**DRAFT**  
**Final Mitigated Negative Declaration**  
**Stormwater Capture Parks Program**

**CEQA Initial Study and Mitigated Negative Declaration  
Stormwater Capture Parks Program**

### **Response to Comments**

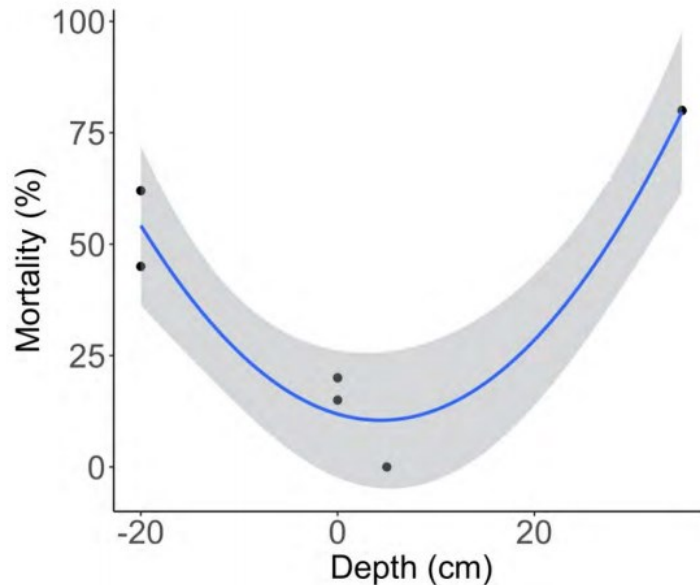
The Draft IS/MND concludes that "no beneficial uses would be impacted." The Draft IS/MND does not offer a quantitative analysis as to how it determined no impacts would occur. Moreover, the Draft IS/MND does not define what it considered to be "beneficial uses." Diverting water during the dry season could reduce the availability and extent of shallow water sheet flow downstream. This could potentially impact algae, benthic invertebrates, and birds. Willow riparian habitat may be impacted if reduction in flow leads to receding shoreline or lower water depth. Preliminary work of the Los Angeles River Flows Project show that black willow (*Salix gooddingii*) seedling mortality increases as water depth decreases (SWRCB 2019). Loss of suitable habitat may impact sensitive species such as least Bell's vireo. Anadromous fish have specific habitat requirements including water depth, velocity, and vegetation.

The comment cites information from a report published for the Los Angeles River Flows Project in January 2021 that provides a habitat suitability assessment for species known to occur in the Los Angeles River. The citation notes that black willow seedling mortality increases with water depth reduction. This information is extracted from a life stage suitability curve provided in the report. The Assessment Report does not provide a conclusion on the optimal water flow depth in

the Los Angeles River. Rather, the Habitat Assessment Report (SCCWRP 2021a) provides suitability curves that show a relationship with water depth and different life cycle stages for various species.

The figure below taken from that report shows that willow seedling mortality is more complex than stated in the comment: mortality is at a minimum at mean depths of around 5 cm and then increases with both reductions and increases in flow depth. In other words, germination occurs within a specific range of flow depth.

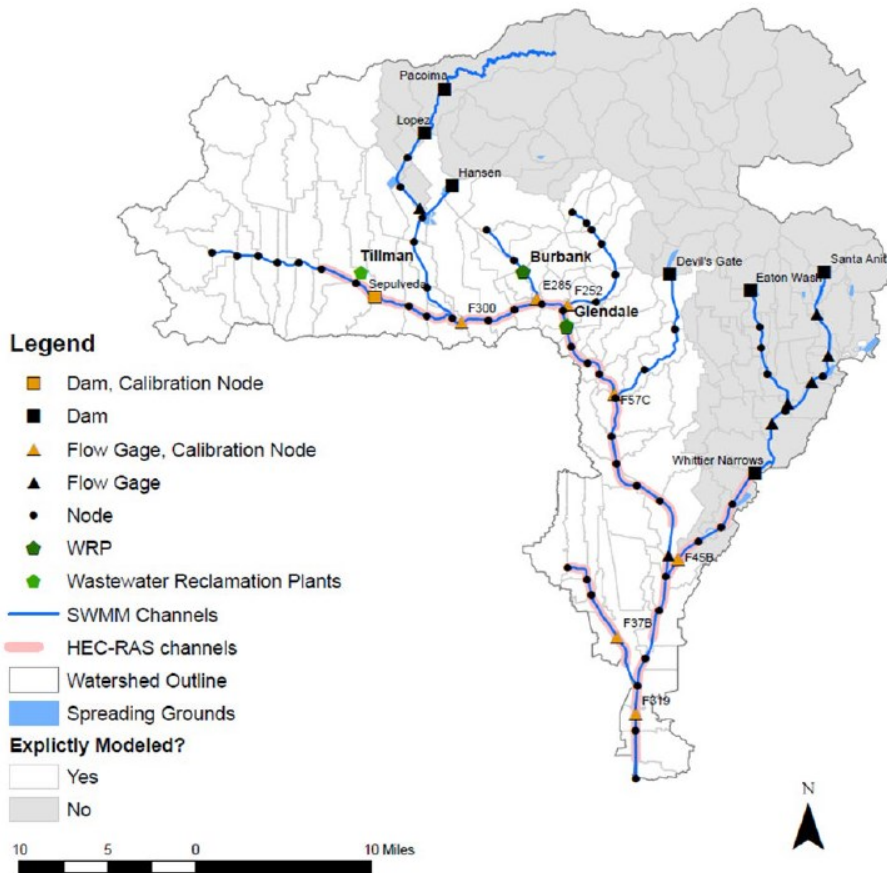
1. CDFW recommends LADWP define the study area as a 15-mile reach of the Los Angeles River, bounded by the Los Angeles River’s confluence with the Tujunga Wash tributary and proceeding downstream to the river’s confluence with the Arroyo Seco tributary. LADWP should identify all sources of flow input within the study area to estimate the total annual and dry season flow. LADWP should assess potential Project related impacts on biological resources within this study reach.

With respect to the Study Reach, the Los Angeles River Flows Project includes assessments of habitat values in the entire Los Angeles River from the Sepulveda Dam to the Pacific Ocean. This study area is larger than requested in the comment. The model domain included as Figure 5 in the study is included below. The Tujunga Central Branch channel confluences with the Los Angeles River at approximately node F300 shown in in the figure.

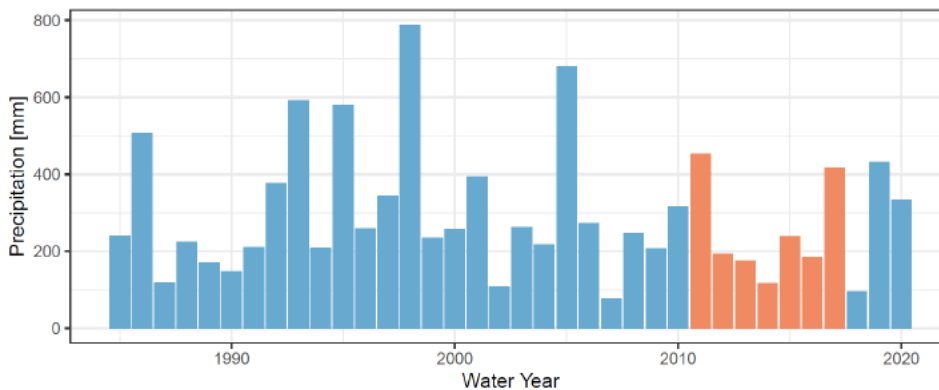
- Under pre-Project (i.e., baseline) conditions, the volume of water flow from the Tujunga Central Branch channel into the 15-mile study reach during a) the wet (November through March); b) the dry season (April through October); and c) above-average and below-average water year (i.e., wet season/above-average water year, wet season/below-average water year, dry season/above-average water year, and dry season/below-average water year). LADWP should clearly define what it would consider to be above-average or below-average rainfall year.

With respect to Changes to Hydrology and Hydraulics, the Los Angeles River Flows Project includes results from a comprehensive modelling effort that meets all the parameters in the comment. As noted on pages 7 through 9 of the study, estimated flow conditions were modeled using a coupled hydrologic-hydraulic model created in EPA’s Storm Water Management Model (SWMM) and the Hydrology Engineering Center’s River Analysis System (HEC-RAS). The hydrologic model simulates discharge on the mainstem of the LA River, Compton Creek, and Rio Hondo at an hourly time step from WY 2011 through 2017. The model includes wet season and dry season discharges and uses a dry period to represent conservative flow estimates as shown in the figure below taken from Figure 3 of the study.

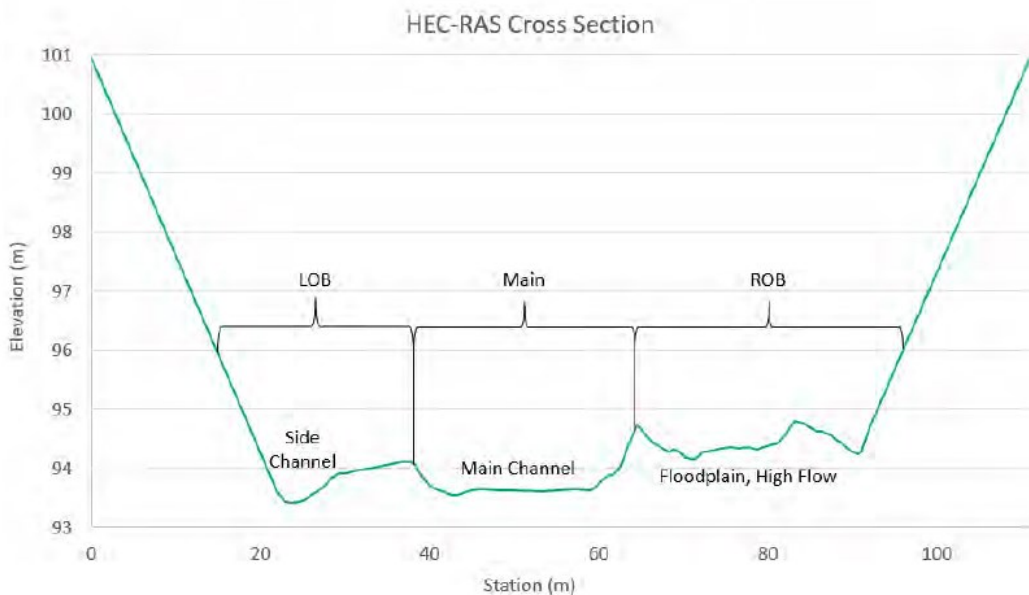
4. An analysis of potential Project-related changes to river hydraulics in both concrete and soft-bottom reaches. This includes water depth (percent change), wetted perimeter (acres gained/lost), and velocity (percent change). CDFW requests a map modeling potential changes to channel hydraulics overlain on a map of plant communities and habitat for sensitive wildlife species and birds.

The figure below provided on page 15 of the Assessment of Aquatic Life Report shows how channel characteristics were accommodated in the ecological-flow relationship analysis provided in the report. Habitat suitability curves were developed to reflect water depth and velocity requirements of existing habitat within these three different parts of the channel: side channel, main channel, and high floodplain. Although the Assessment of Aquatic Life Report does not provide a map of the habitat within the Los Angeles River associated with each of these cross sections, it does inventory the species and habitat values that occur within the soft-bottom portion of the river (the 15-mile segment highlighted in the comment) and presents a detailed HEC-RAS model that provides depth and width impacts associated with flow reductions at specific cross section locations that were also measured in the field for model calibration purposes. The evaluation of habitat suitability within this segment of the river (see graph provided in response to comment 5-F) is then expressed in cubic feet per second (cfs) impacts rather than depth and width in order to provide a meaningful model for the total 15 miles of the soft-bottom segment.

**Figure 34. Map of study reaches with identified habitats that could potentially be supported in each reach.**

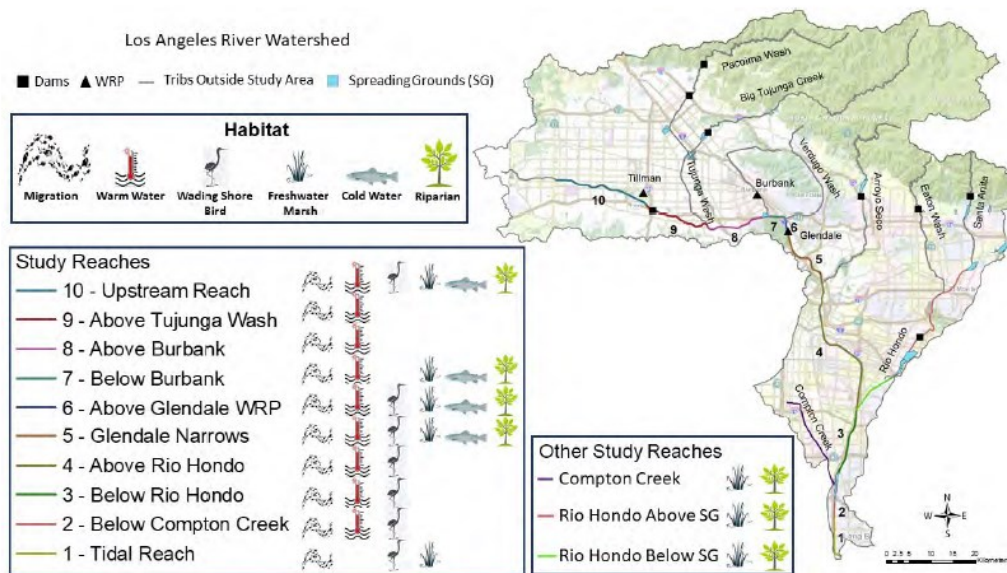
1. A map of plant communities and important bird foraging and nesting habitat occurring in the 15-mile study reach. Plant communities should be mapped at the alliance/association level using the Manual of California Vegetation, second edition (Sawyer et al. 2009). Also, CDFW recommends an updated and thorough floristic-based assessment of plant communities, following CDFW's Protocols for Surveying and Evaluating Impacts to Special Status Native Plant Populations and Sensitive Natural Communities (CDFW 2018).

The Assessment of Aquatic Life Report provides an inventory of habitat and species occurrences within the 15-mile segment mentioned in the comment. Figure 34 of the Assessment of Aquatic Life Report reproduced below illustrates which reaches exhibit aquatic and riparian habitat values. Habitat mapping was not conducted as part of the study. Rather, flow ranges supporting habitat suitability for all aquatic values were developed, assuming that the entire 15-mile river segment may exhibit habitat values.

Figure 33. Species observations along the mainstem of the LA River and tributaries included in this study.

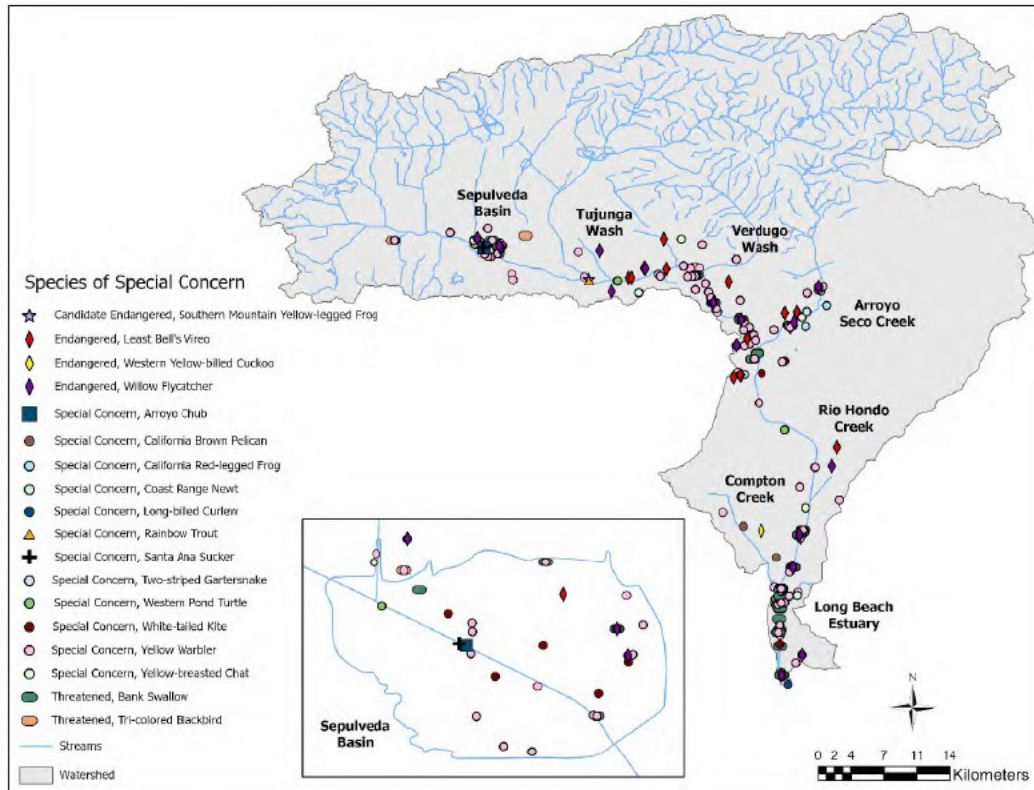
2. A comprehensive list of sensitive and special status plant and wildlife species, and sensitive plant communities, occurring in the 15-mile study reach. CDFW recommends a nine-quad search of the California Natural Diversity Database (CNDDDB) for sensitive and special status biological resources that could occur downstream. For each biological resource, provide:
  - d. A summary of species-specific habitat requirements;
  - e. A discussion as to how the species or plant community may be significantly impacted directly or indirectly through habitat modification, as result of changes to hydrology (reduced flow) and hydraulics (water depth, wetted perimeter, velocity); and,
  - f. A quantitative analysis and/or adequate discussion to evaluate whether the Project would result in those significant impacts.

The Assessment of Aquatic Life Report provides the CNDDDB listed species of concern in a concise map excerpted below. Beginning on page 38, the Assessment of Aquatic Life Report provides a summary of “life history needs” for key species within the habitat types. Habitat suitability curves are prepared based on the target vegetation’s needs for water as measured by flow in the river (ie., cfs). This analysis defines future water flow reductions as the impact, and provides suitability curves to evaluate significance of the impact. The graph included in response to comment 5-F summarizes the relationship of flow in the river with habitat suitability for willow habitat. Since willow habitat (the key indicator species for riparian values in Southern California) is sustained with substantially less flow than currently exists or is projected to exist with future flow reductions, the contribution of 4 percent flow reduction resulting from the proposed project is considered cumulatively less than significant. That is to say, the scientific analysis contained in the LA Rivers Flows Project Final Report and companion study Assessment of Aquatic Life Report provide the information requested in this comment and support the conclusions of the IS/MND.
